Disari Apparels (Pvt) Ltd & Disari Industries (Pvt) Ltd Gold Star Fashions Ltd

B-193, BSCIC Industrial Estate, Tongi, Gazipur, Dhaka
(+23.89271N, 90.41537E)

1 March 2014

Building Observations

Construction Drawing

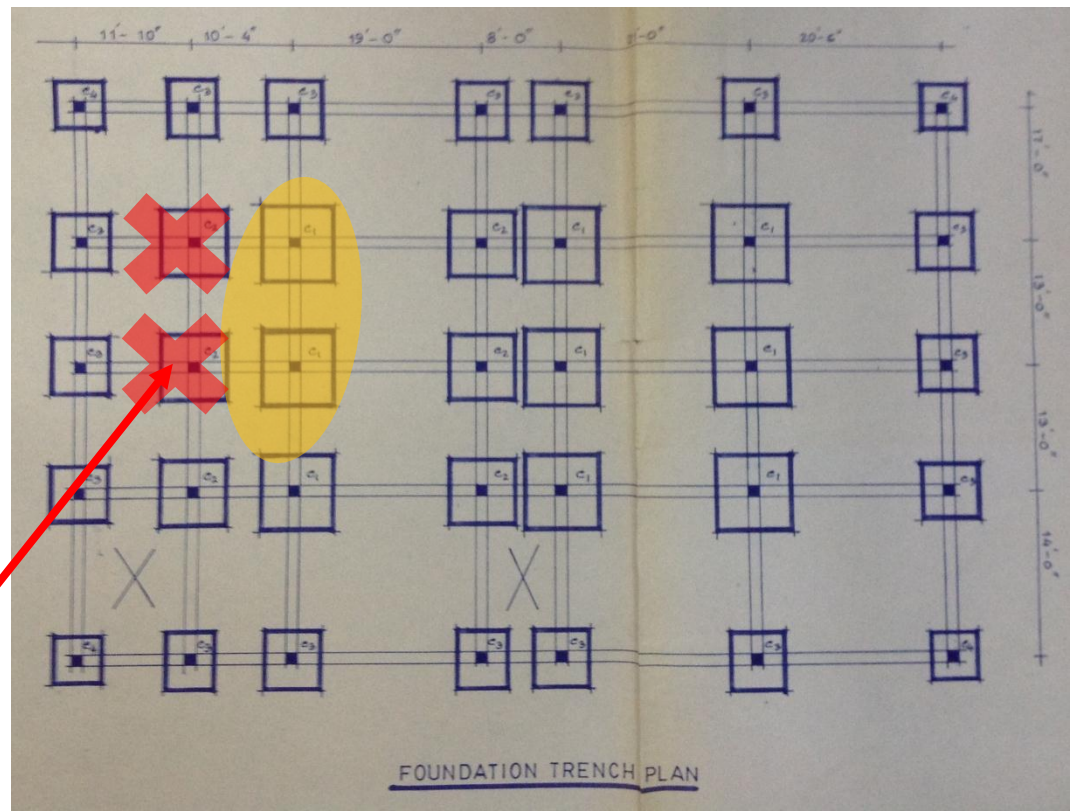
Discrepancies between permit drawings, structural drawings and as-constructed grids/column locations to be reviewed by Building Engineer.

These columns not constructed
